# NOTICE OF DECISION

**TENTATIVE PARTITION PLAN / CLASS 2 ADJUSTMENT CASE NO.: PAR-ADJ23-04**

**REQUEST:** A consolidated Tentative Partition Plan to divide a 20.5-acre lot into three parcels, with Parcel 1 and Parcel 2 consisting of approximately 5 acres each, and Parcel 3 consisting of approximately 10.5 acres, with two Class 2 Adjustment requests to:

The subject property is approximately 20.5 acres in size, zoned RA (Residential Agriculture), and located at 5791 Skyline Rd S (Marion County Assessor's Map and Tax Lot Number: 083W17C / 100).

**TENTATIVE  
PARTITION PLAN**

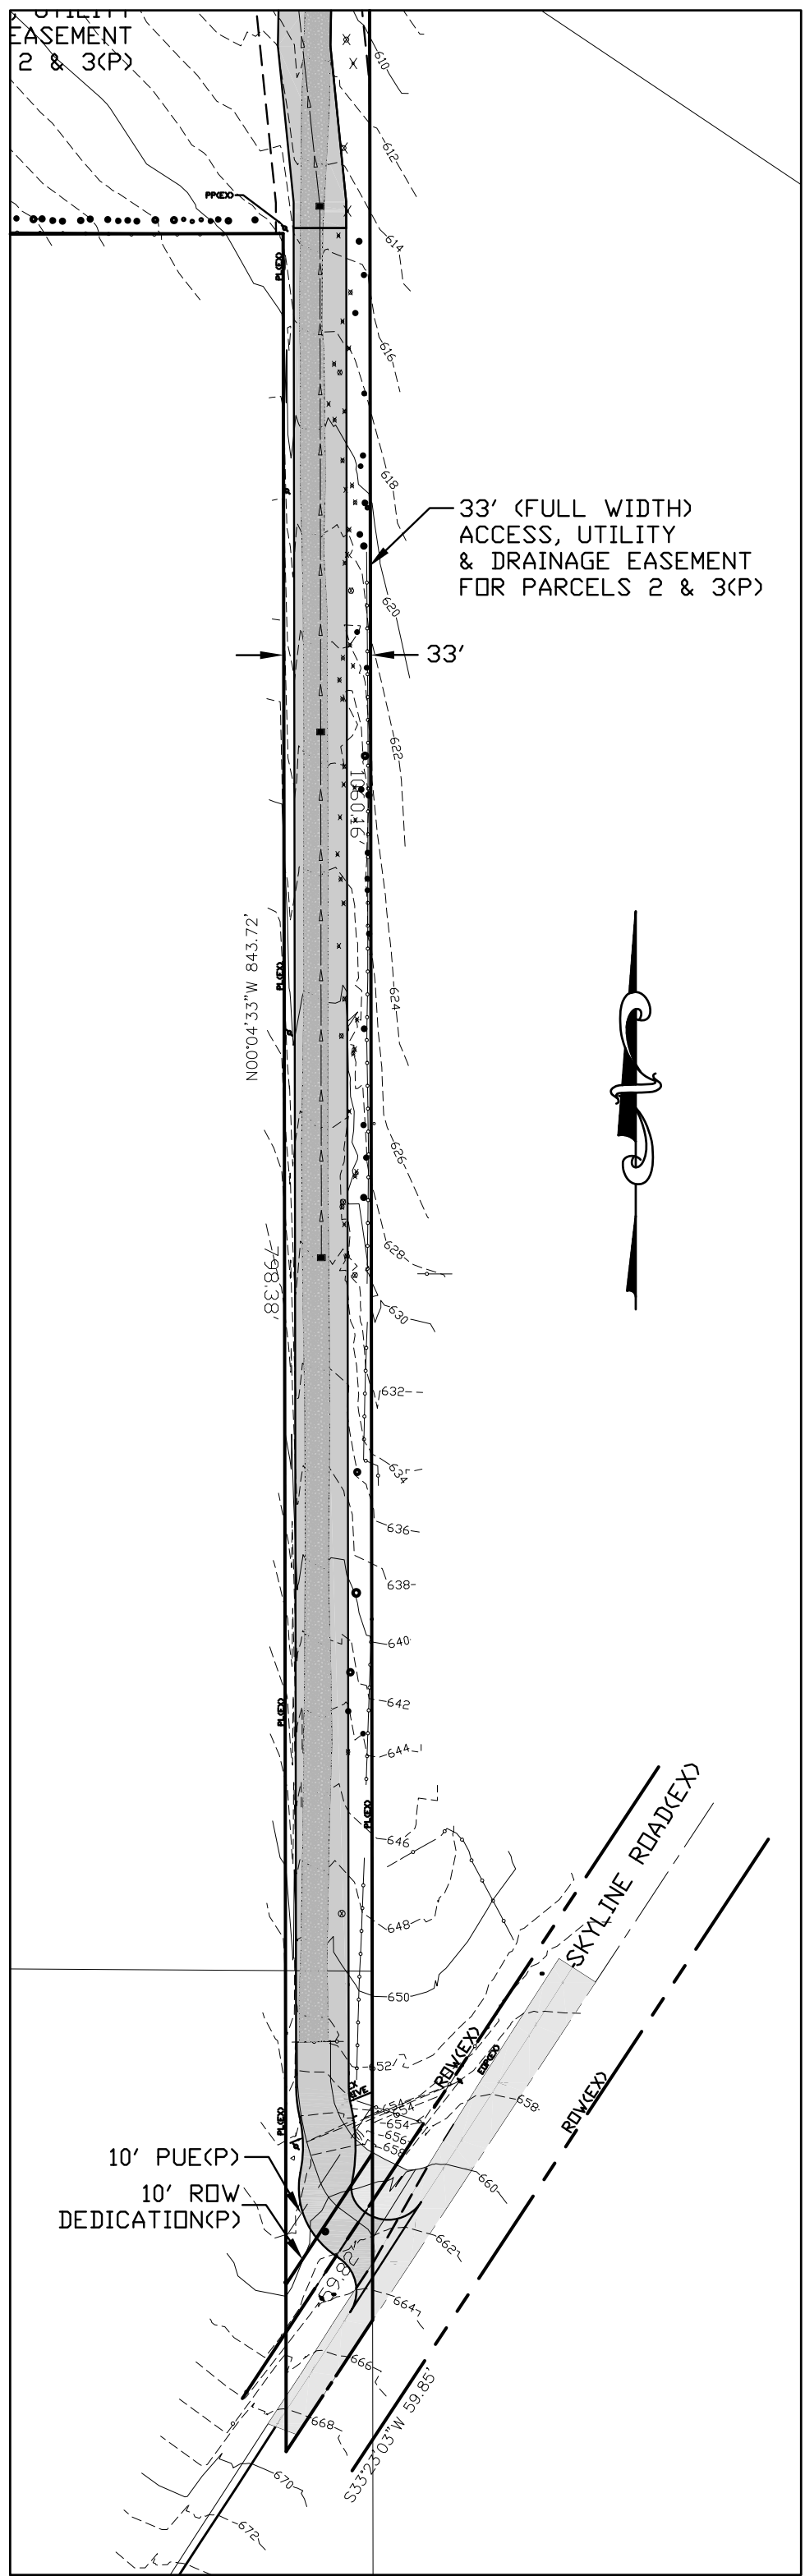
The applicant submitted a shadow plat as part of the application which demonstrates how the property could be further divided. The shadow plat does not appear to take into account existing topography of the site; streets as shown may not meet minimum standards in SRC Chapter 803 for grade. Additionally, the shadow plat does not provide the maximum 600-foot block spacing required, nor does it provide adequate street connectivity to adjacent vacant parcels. The shadow plat could not be approved without accompanying Alternative Street Standard approvals and/or Design Exceptions. As such, the following condition applies:

**Finding:** Because the proposed flag lot accessway is serving three lots, or a minimum of three units, the accessway is required to be improved to a minimum width of 20 feet within a 25-foot-wide easement and cannot exceed a maximum length of 400 feet. As shown on the tentative partition plan, a flag lot accessway will be serving all three lots at a length longer than the maximum allowed 400 feet. The applicant has requested a Class 2 Adjustment to this length due to the unique configuration of the subject property. Findings for the adjustment are included in Section 9 of this report.

As shown on the tentative partition plan, the flag lot accessway is proposed to be 25-feet in paved width, approximately 780 feet in length, and paved to a width of 20 feet in conformance with the requirements of SRC 800.025(c). Because the length of the flag lot accessway is greater than 400 feet, Fire Department Turnaround and Turnouts are required, as indicated above. Due to the location of the property and neighboring properties designated under County jurisdiction, and the need to serve two parcels beyond proposed Parcel 1, there is no other option than to exceed the 400-feet maximum length. Condition 1 above requires the applicant to provide plans indicating conformance with Fire Department standards at the time of final plat review.

**Finding:** A portion of the Croisan Creek runs through the western portion of the subject property, creating a riparian corridor. Pursuant to SRC 808.035, the tree conservation plan submitted in conjunction with the partition tentative plan identifies a total of 487 trees on the subject property, 75 of which are identified as significant trees, and 66 of which are riparian trees located within the riparian buffer of Croisan Creek. The existing conditions of the property identify 76 trees located within the extensive flag lot accessway leading to the property.

Because of this, improvements to the accessway to provide paving and safe access to the property affect the critical root zone of every single tree within that accessway.

- Condition 4:** The flag lot accessway shall be paved to a minimum width of 20 feet within a minimum 25-foot-wide easement.
- Condition 5:** “NO PARKING–FIRE LANE” signs shall be posted on both sides of the portion of the flag lot accessway that is a fire apparatus roadway and “NO PARKING” signs shall be posted on both sides of any remaining portion of the accessway.

- Condition 9:** Relocate the driveway approach to Skyline Road S into the flag lot portion of the property or demonstrate an access easement exists that allows the existing approach to encroach onto neighboring property.

- Condition 17:** Provide a turn-around off the flag lot accessway to ensure forward in/forward out movement onto Skyline Road S.
